London Luton Airport Expansion

Volume 8 Additional Submissions (Examination) 8.186 Applicant's Response to Examining Authority's Rule 17 Request Dated 25 January 2024

Application Document Ref: TR020001/APP/8.186

Figure A.1.1: Daytime Updated Faster Growth (UFG) and indicative Core case Limits and forecasts

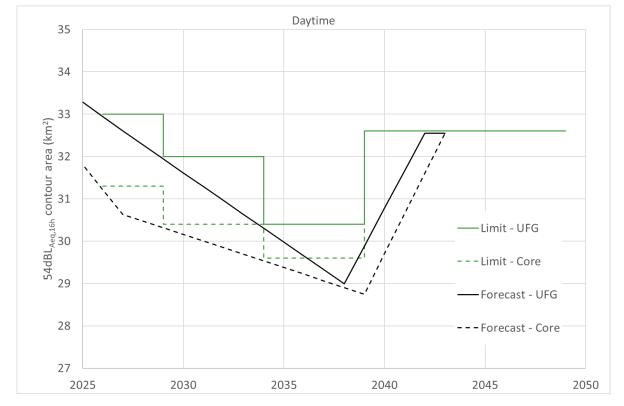
"Provide a detailed explanation of how the core growth and faster growth limits set out in Applicant's Response to Written Questions – Green Controlled Growth (GCG) [REP7-054] relate to the assessment tables provided in ES Appendix 16.1: Tables 7.40, 7.43, 7.46, 7.49, 7.52 and 7.55 [REP7-013] that set out the Applicant's assessed likely and worst case(s). In responding explain why interpolation would mean that values were set higher than an individual peak year."

- A.1.1.2 The Noise Envelope Limits are based on an interpolated forecast between assessment years. The interpolation results in Limit values being different to those in the individual assessment years as the assessment phases do not align (in number or duration) with the five-yearly noise limit phases.

- A.1.1.3 Table A.1.1 shows the interpolated forecast for the Core case, using the assessment year contour area values from Tables 7.40, 7.43, 7.46, 7.49, 7.52 and 7.55 of Appendix 16.1 of the ES [TR020001/APP/5.02]. Next to these are the derived noise Limits (as presented in response to Written Question GCG.2.4 [REP7-054]), which are calculated based on the highest contour area within each five-year period. This is also illustrated graphically in Figure A.1.1 and Figure A.1.2 which show that if any of the Limits were decreased, the forecast would result in breaches of noise Limits between assessment years.

- A.1.1.4 **Table A.1.2** shows the equivalent data for the Updated Faster Growth forecast introduced in the **Applicant's Position on Noise Contour and Movement** Limits [TR020001/APP/8.184], using the assessment year contour values from Tables 6.1 and 6.2 of the **Applicant's Position on Noise Contour and Movement Limits** [TR020001/APP/8.184] (for 2027) and Tables 12.12 and 12.13 of **Appendix 16.1 of the ES** [TR020001/APP/5.02] (for 2038 and 2042). The data is also shown graphically in Figure A.1.1 and Figure A.1.2.

- A.1.1.5 In deriving Limit values, the largest contour value in each five-year period is rounded up to the nearest 0.1 km². The approach of rounding upwards is considered appropriate when setting limits/caps. The approach also avoids the situation in which a potential breach of a Limit could be unreasonably exaggerated due to rounding. For example, the 'up to 2028' Limit of 33.00 km² is based on a calculated contour area of 32.94 km² in 2026 (see **Table A.1.2**). Using traditional rounding would result in a Limit of 32.90 km², which could then result in a breach if the actual contour area was 32.95 km², despite an increase in contour area against the value used to set the Limit of only 0.01 km² (0.03%). Contour areas are shown in **Table A.1.1** and **Table A.1.2** to two decimal places to illustrate the implications of rounding.
